MONTGOMERY COUNTY DEPARTMENT OF PARK AND PLANNING

**MCPB
1/22/98
Item #9**

MEMORANDUM

DATE: January 16, 1998
TO: Montgomery County Planning Board
FROM: Wynn E. Witthans, ASLA, AICP *W*
Development Review
Planning Department Staff
(301) 495-4584
VIA: Charles Loehr, Chief, *CL*
Development Review
REVIEW TYPE: Site Plan Review
APPLYING FOR: 768 units: 75 SFD, 295 Townhouses, 398 multifamily inclusive of 96 MPDU's
PROJECT NAME: Clarksburg Town Center - Phase I
CASE #: 8-98001
REVIEW BASIS: 59-D-3 of the Montgomery County Code is required for the optional method of development in this zone.
ZONE: RMX-2, Residential Mixed Use Development, Specialty Center
LOCATION: Northeast of the intersection of Clarksburg Road and Stringtown Road
MASTER PLAN: Clarksburg Master Plan and Hyattstown Special Study Area, June 1994
APPLICANT: Clarksburg Land Associates L.P. and Piedmont Land Associates L.P. and T/A Clarksburg Town Center Venture
FILING DATE: August 1, 1997
HEARING DATE: January 22, 1998

Applicant's Proposal 30

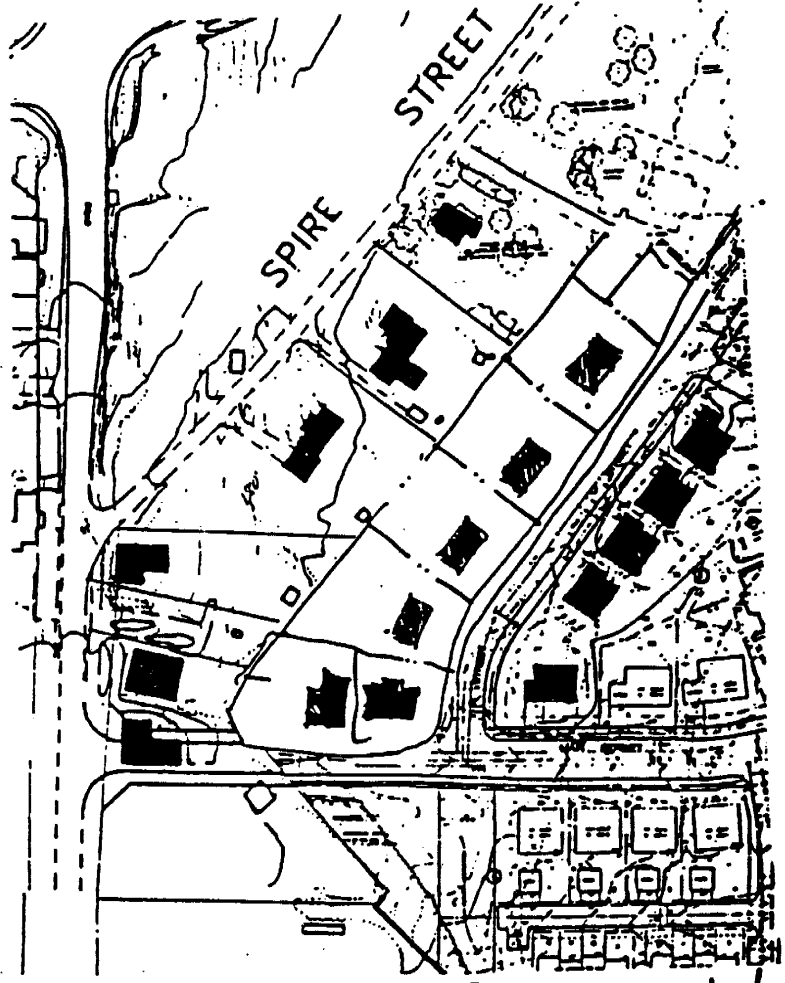
In the context of the site plan review, the HPC reviewed the project and found several requirements outstanding and has passed on the following recommendations: a 20 ft setback, free of a public utility easement, from the right-of-way to the historic Day house at the corner of MD 355 and Stringtown Road; appropriate lighting on Stringtown Road to be compatible with the Historic District; the CTC developer and Aric Ruddin should continue to resolve their issues to allow the Main Street connection to occur opposite Redgrave Place; a detailed design for a public space/interpretative area

The removal of a proposed house is to create compatibility between the two projects utilizing similar scaled and dimensioned buildings and surrounding open spaces. The existing condition on Spire Street has three homes that have lot widths at their building face of 130 ft, 115 ft and 180 ft. The lots along MD 355, whose rear yards adjoin the common boundary, have 40 and 60 foot widths at the front building line. The proposed six lots have 2 lots with 68 foot widths at the front building line, one lot at 65 feet, one lot at 990 feet, one lot at 88 feet and one lot at 120 feet. The average frontage for all six lots is 83 feet. The approved Project Plan condition reads: "...the size of lots and setbacks of the proposed development must match, approximately, the development standards in the R-200 Zone for building setbacks and width of lots along the southeastern boundary of the site..." The required lot width along the front building setback line is 100 feet. The dimensions of the proposed lot widths and the sketch below show the lack of conformance with the desire of the HPC and the Planning Board's earlier decisions. The staff proposal clearly shows that the 100 foot lot widths work to create an appropriate transition between the existing Historic District and the proposed units. See memo of January 15, 1998 from the Historic Preservation Commission in the Appendix.

32. One lot should be deleted from the single family home area directly adjacent to the Historic District, to fulfill the Project Plan condition to approximate R-200 zone lot width standards.
